Access Compliance Report

Public Rights-of-Way

(Curb Ramps)

Intersection ID: 27422	Main Street: BALLANTYNE COMMONS PY	Cross Street: STONEBRIAR DR	Location: NE
ADA ID: 1BD74AE29509	Ramp Type: Perp	Initial Pass/Fail: Fail	Overall Compliance: No
Severity Score: 42.5			
Codes/Mitigation Info/Possible Solution		Field Measurements/Component Compliance

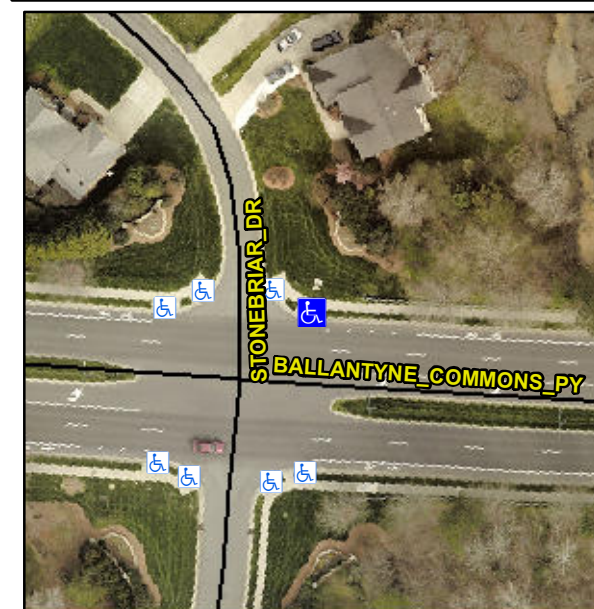
Not Found, R304.5.1, R304.2.2, R304.5.3

Compliance	Description	Data	Compliance	Description	Data
N/A	Ramp Length (in)	110.0	No	Ramp Slope (%)	9.2
No	Ramp Width (in)	34.0	No	Ramp XSlope (%)	5.6
N/A	Flare Type LT	N/A	N/A	Flare Type RT	N/A
N/A	Flare Slope LT (%)	N/A	N/A	Flare Slope RT (%)	N/A
N/A	Flare Traversable LT?	N/A	N/A	Flare Traversable RT?	N/A
N/A	Landing Length (in)	N/A	N/A	DWS Provided?	N/A
N/A	Landing Width (in)	N/A	N/A	DWS Contrast?	N/A
N/A	Landing Slope (%)	N/A	N/A	DWS Length (in)	N/A
N/A	Landing X Slope (%)	N/A	N/A	DWS Full Width?	N/A
N/A	Landing Curb? (Y/N)	N/A	N/A	DWS Offset (in)	N/A
N/A	Shared Landing?	N/A			
N/A	Gutter Ponding?	N/A	N/A	Gutter Slope (%)	N/A
N/A	Gutter Lip Ht (in)	N/A	N/A	Gutter X Slope (%)	N/A
N/A	Painted X Walk1?	No	N/A	Painted X Walk2?	N/A
	X Walk 1 Direction	To S		X Walk 2 Direction	N/A
N/A	X Walk 1 Width (in)	N/A	N/A	X Walk 2 Width (in)	N/A
	X Walk 1 Slope (%)	4.1		X Walk 2 Slope (%)	N/A
	X Walk 1 X Slope (%)	3.3		X Walk 2 X Slope (%)	N/A

Remove & Replace Entire Ramp.
